April 21, 2021

Ref: 73152.00

Re: 16 Bulge Road - Devens, MA

Below are responses to compiled review comments provided on the April 8, 2021 from Mass Development, Peer Reviewers, and the Devens Enterprise Commission. Comments are reiterated below with VHB responses following in italics.

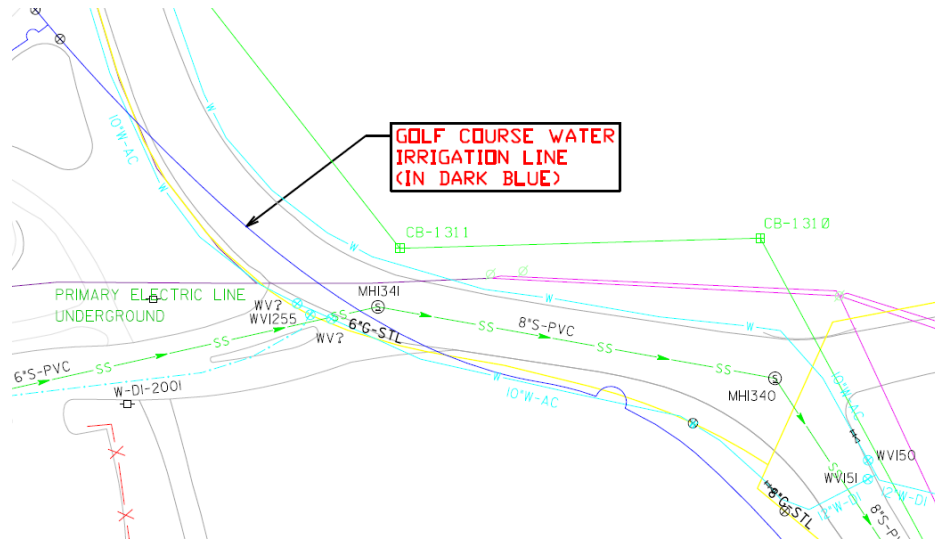
Comment 35: Devens GIS shows a golf course water irrigation line close to the existing sewer manhole that the new sewer from the site would tie into on Bulge Road near the entrance driveway to the golf course clubhouse. That SMH is noted as MH 1341 on the following plan.

The irrigation line is shown in dark blue. This line as shown on the plan should be taken as an approximate location since I am not sure if we accurate information as to its exact location. Since this is a private line, it may not be marked out by Dig-Safe when the project's contractor submits a Dig-Safe request. Also shown on the plan is an approximate location of the underground primary electric feed to the clubhouse. This underground line is referred to in Utility Plan C-5 comment below.

Response: *Acknowledged. The irrigation line and the underground electric have been added to the plan based on the provided GIS. A test pit is noted to be required to identify location and elevation of the comm and electric. Some adjustment to the manhole location may be required based upon actual location of the irrigation main and electric/comm conduit.*
